Comments on Draft Permit #12-POY-079

FTS International Proppants, LLC

Acadia, Trempealeau, Wisconsin

March 15, 2013

Figure 1 – Proposed Sand Mine and Plant Location

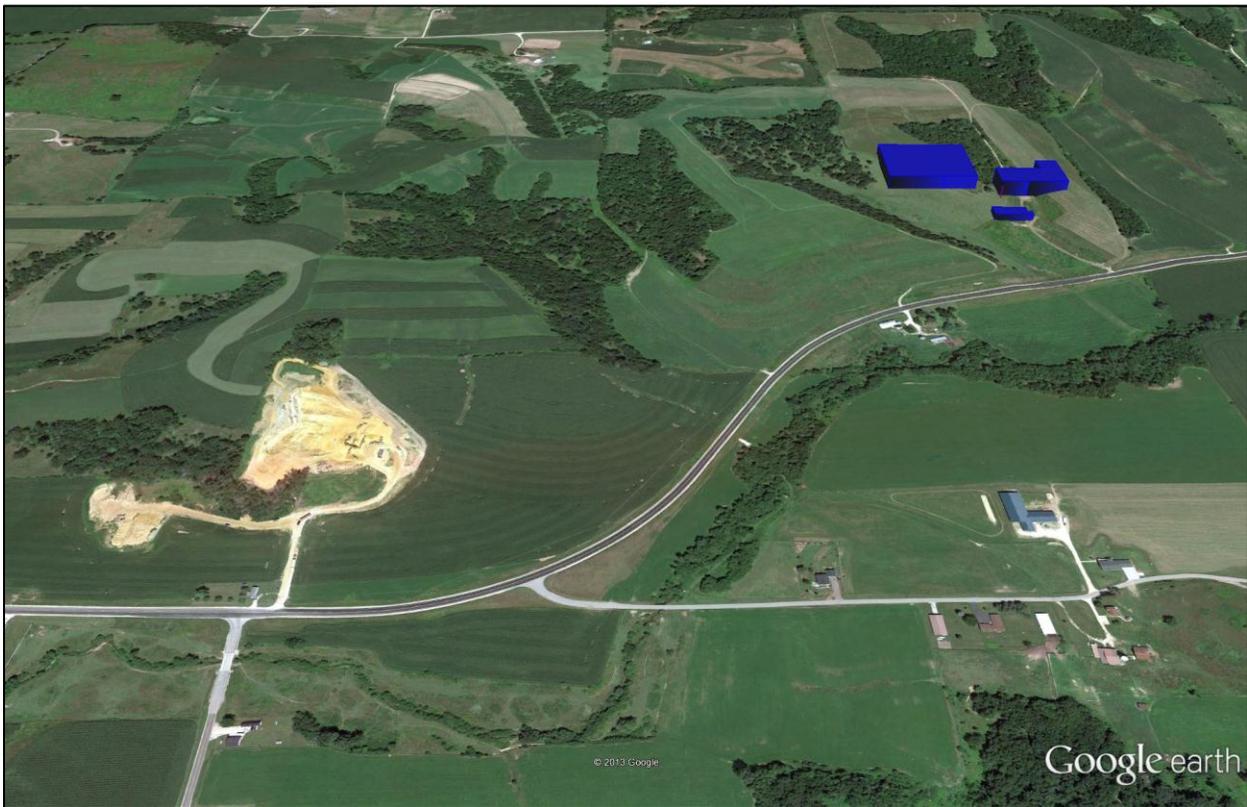
FTS International Proppants, LLC has applied for an air pollution control construction permit to operate a sand mine and processing plant near Acadia, Wisconsin. The DNR draft permit and preliminary determination do not provide a precise location for the mine and plant. However, Figure 1 was developed from the DNR modeling files for the draft permit. This shows the anticipated location of the sand mine and sand plant buildings and sand dryer and dry plant baghouse stacks east of Acadia on Highway 95.
